RFP Title: Trinity Square Area Water Main Rehabilitation

ADDENDUM NO. 3

RE: TRINITY SQUARE AREA WATER MAIN REHABILITATION
CONTRACT NO. 8-23

AREA PLAN 14
 PROJECT NO. 1516-274596
 FILE NAME: CO01PLPR.DWG
 SHEET NO. C-14

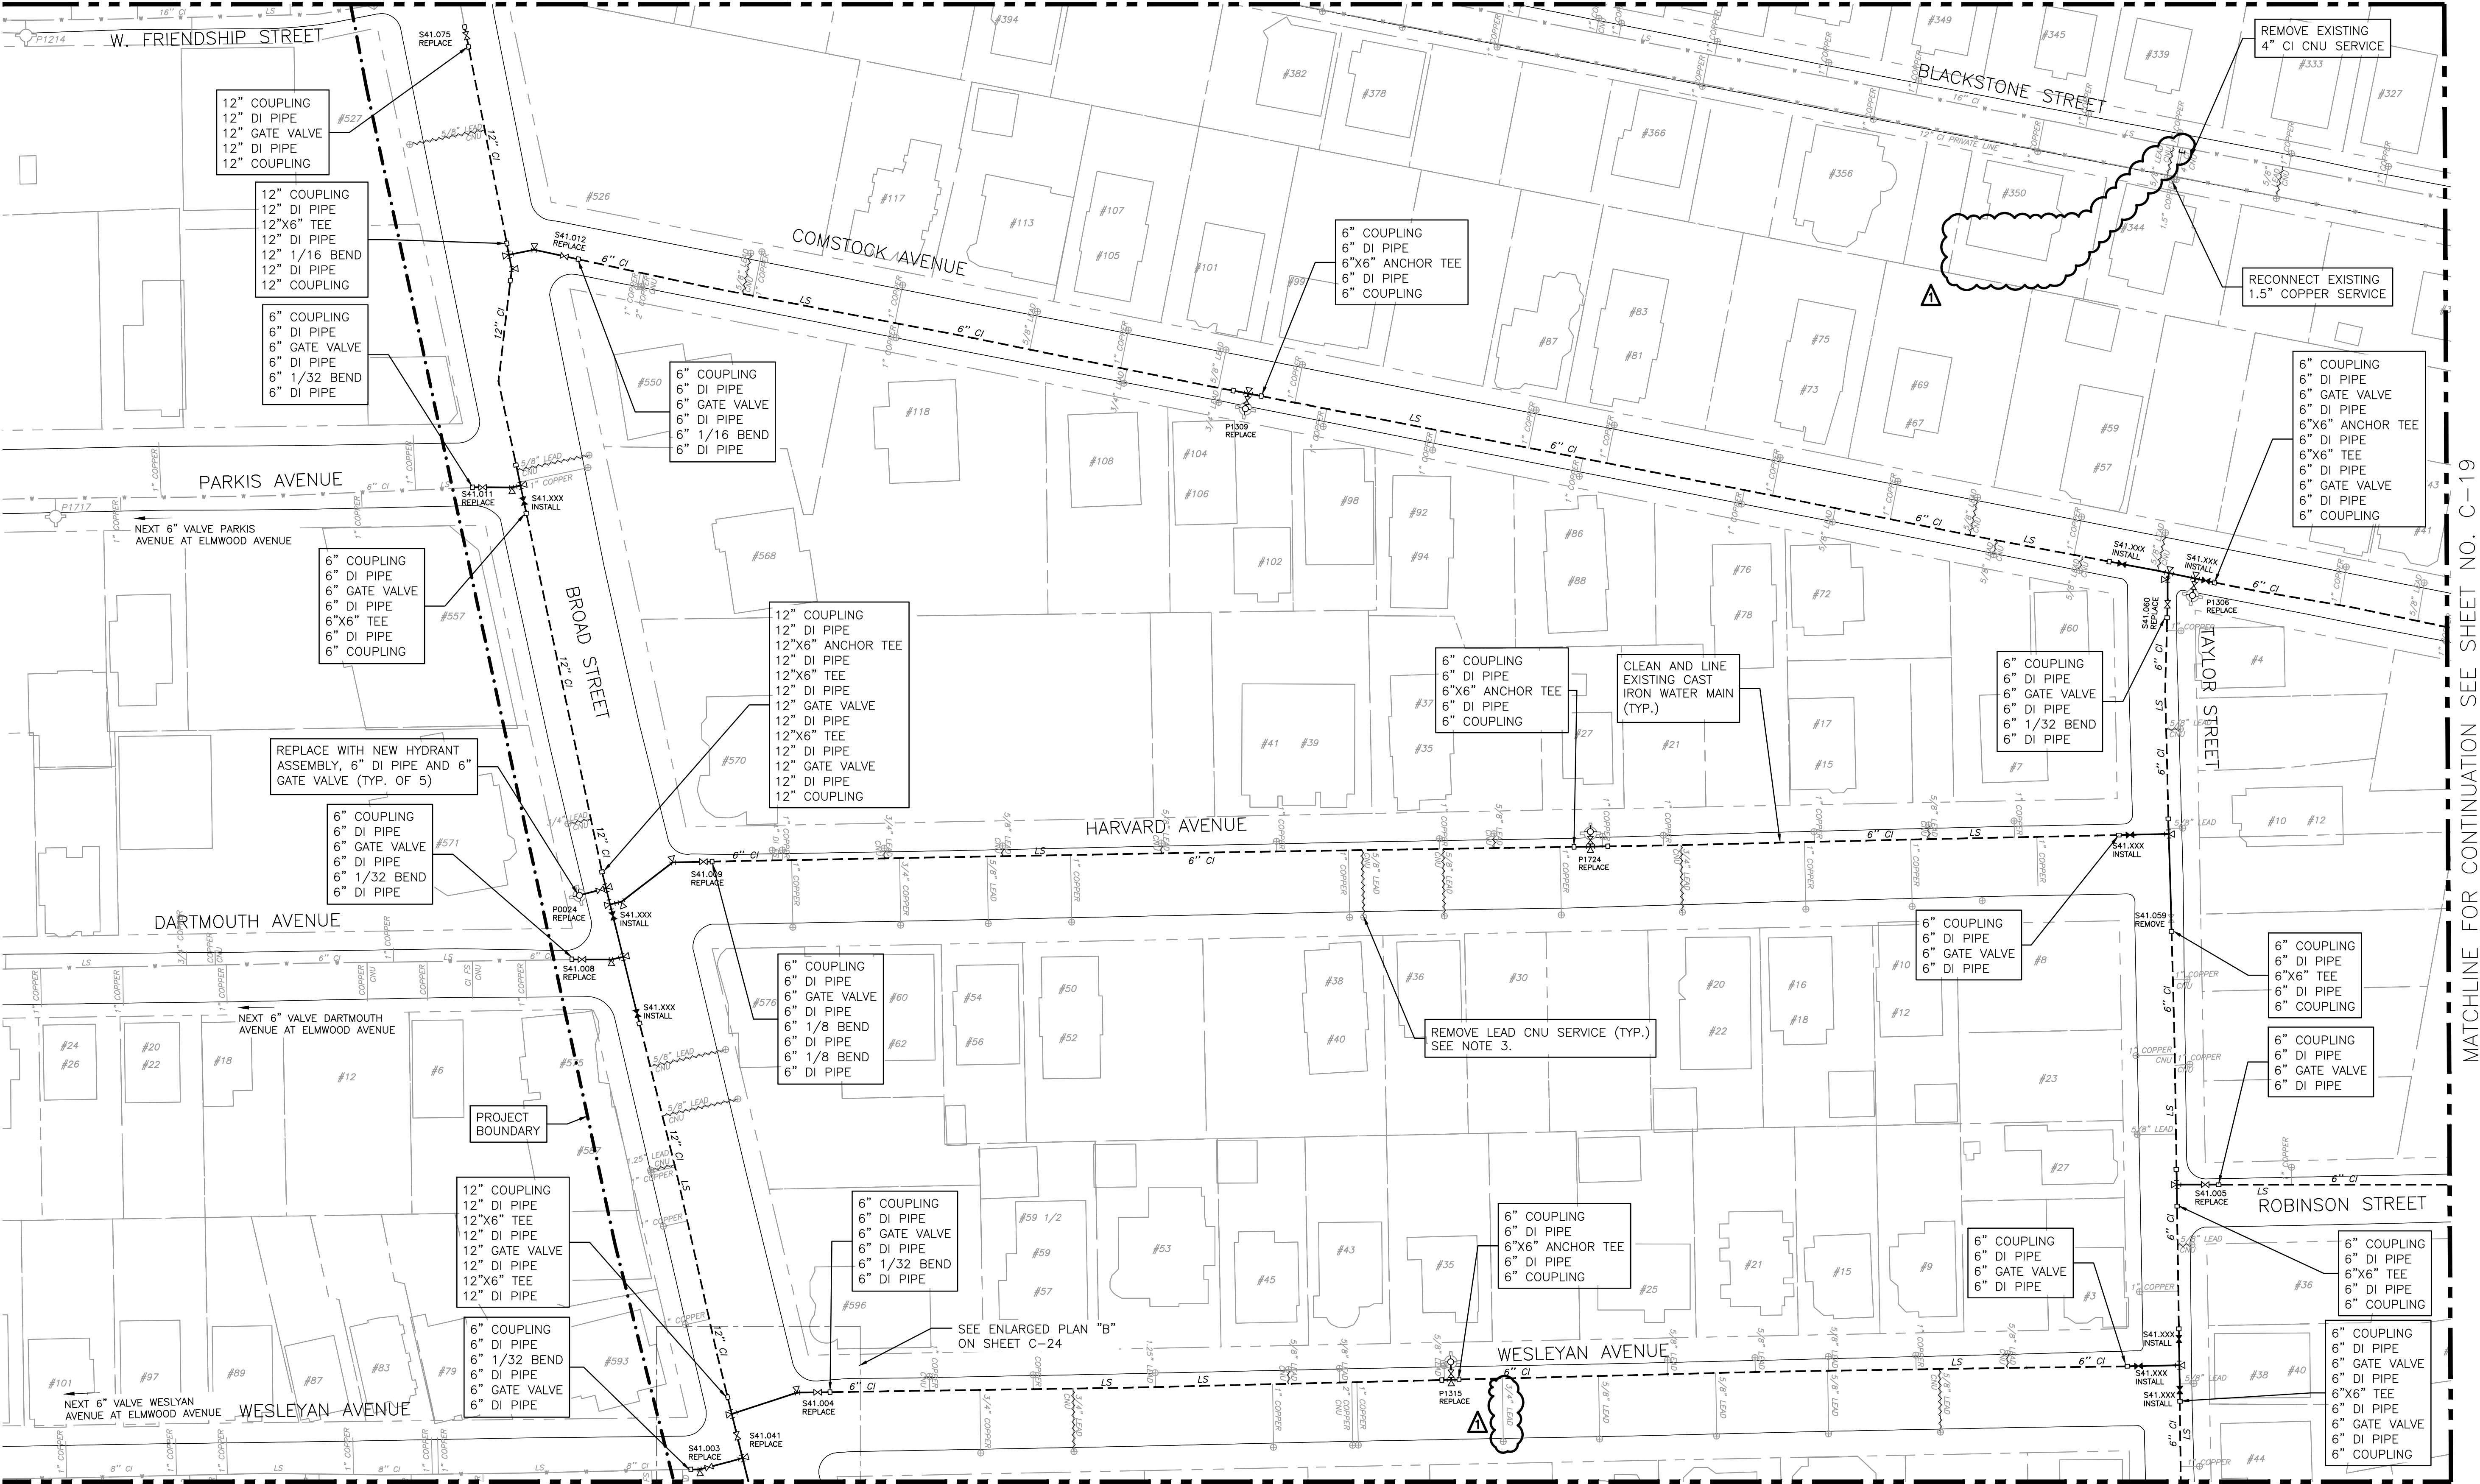
15. QUESTION: On Plain Street (sheet C-9 and C-14) there are several items that need clarification.

RESPONSE: See the Contract Drawings in Attachment No. 3 of this Addendum.

RESPONSE: See the Contract Drawings in Attachment No. 3 of this Addendum.

RESPONSE: This work was revised. See the attached updated Contract Drawing sheets.
